MEMORANDUM

File No.: DRV13-00254

Subject: JUANITA BAY VETERINARY HOSPITAL AND GENERAL OFFICE BUILDING AT 11416 98TH AVE NE- CONCEPTUAL DESIGN CONFERENCE

A10

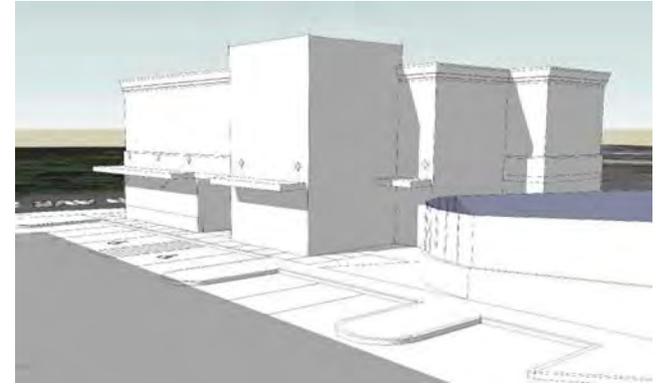
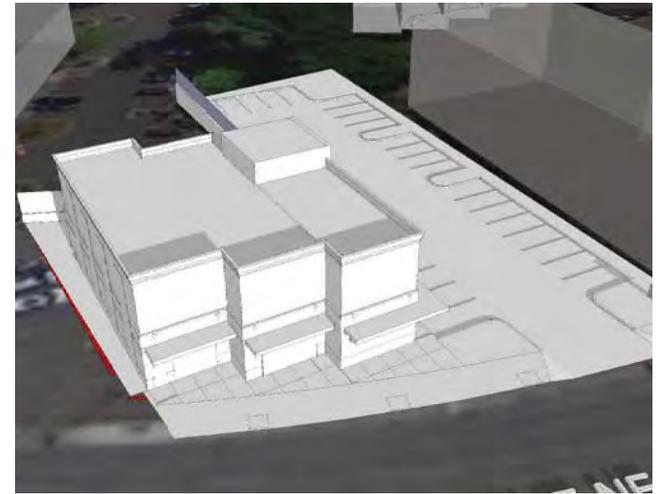
Staff Comment: The applicant proposes a two story building that will take advantage of the allowed additional 13' of height. The applicant has shown the elevation of the properties to the east in relationship to the site and a view analysis showing a view corridor on the south side of the property over the parking lot (Attachment 2 and Attachment 3). Staff has reviewed the materials and generally supports the applicant's initial direction. Because the building location is a critical part of the conceptual design, the DRB should provide input to staff and the applicant regarding the location of the building and which side of the property will provide the widest view corridor.

1. What are the key vantages of the project?
2. Building Height and View Corridor- Discuss the three massing schemes including a preferred option (Option 3) for the DRB's review and comment (see Attachment 2). Provide input to staff on the proposed location for the view corridor given the existing development to the north, south and east and the following site vehicular access constraints.
3. Identify appropriate mitigation techniques for building massing of the proposed buildings. Possible techniques include vertical and horizontal modulation and roof forms.
